**REDUCTION OF LANDSLIDE VULNERABILITY BY MITIGATION MEASURES  
PROJECT (RLVMMP) FUNDED BY AIIB**

**CONTRACT NO: RLVMMMP/GOODS/NCT/04R-LOT 1/2/3/4/5/6/7/8**

**ADDENDUM -01**

**Item 7.8 - Center Work Leveling Table - Main Laboratory**

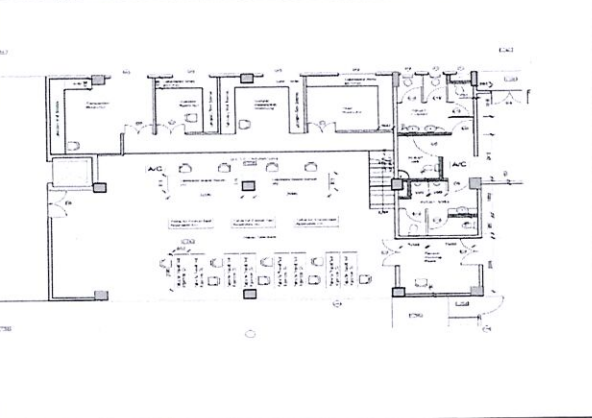
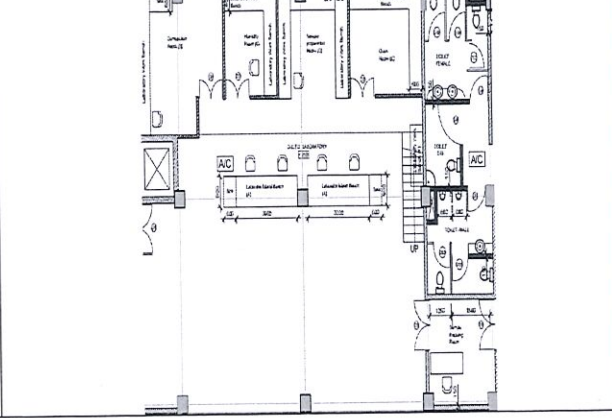
Item No.	Features	Original	Corrected Requirement
7.8.1	Specification	Fixed Drawers for the table (Lockable)	03 Fixed Drawers Cupboards - 1No. (Lockable)
			<b>Add</b> - Fixed cupboard with 02 shelves – 2Nos.(Lockable)

Refer amended page no. 128 in Annex 02 of Addendum 01.

**Item 7.9 - Leveling Table III - Main Laboratory**

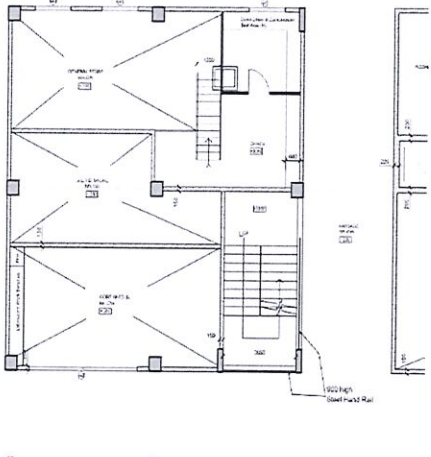
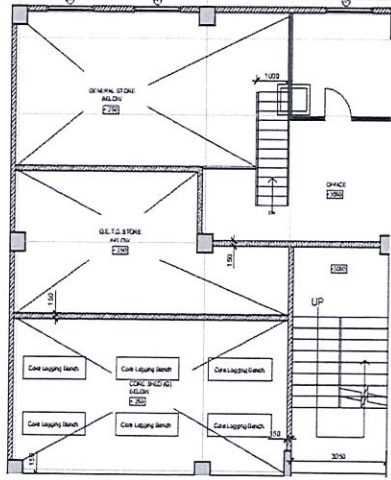
Item No.	Features	Original	Corrected Requirement
7.9.1	Specification	Fixed Drawers for the table (Lockable)	03 Fixed Drawers Cupboards - 1No. (Lockable) Add - Fixed cupboard with 02 shelves - 2Nos.(Lockable)

Refer amended page no. 129 in Annex 02 of Addendum 01.

**Item 7.20 –**

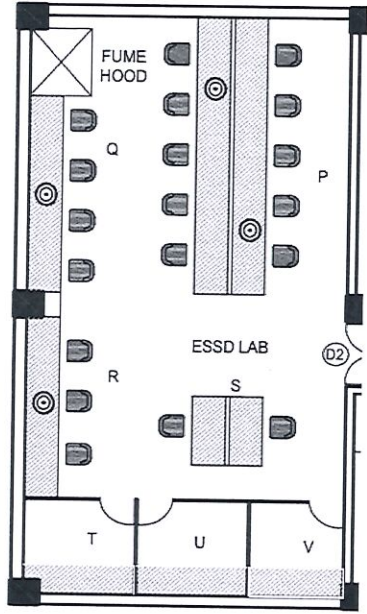
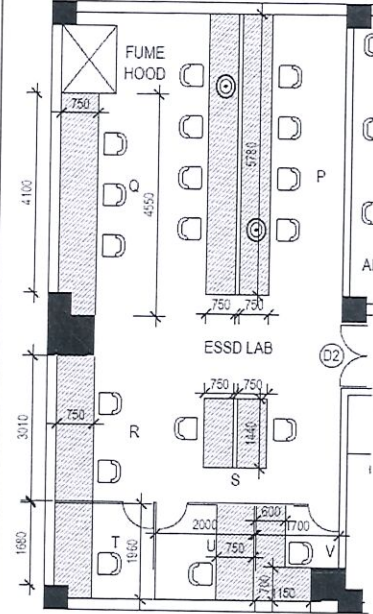
<b>Item No.</b>	<b>Features</b>	<b>Original</b>	<b>Corrected Requirement</b>
7.20		Laboratory work bench II - for Oven room, Core shed areas - (E) & (I)	Laboratory work bench for Oven room, - (E)
7.20.1	Warranty Period	Non corrosive materials, water absorption damages into structural materials and termite attack (if Board used)	Warranty Period- Two years from the date of installation and commissioning

Refer amended page no. 136 in Annex 02 of Addendum 01.
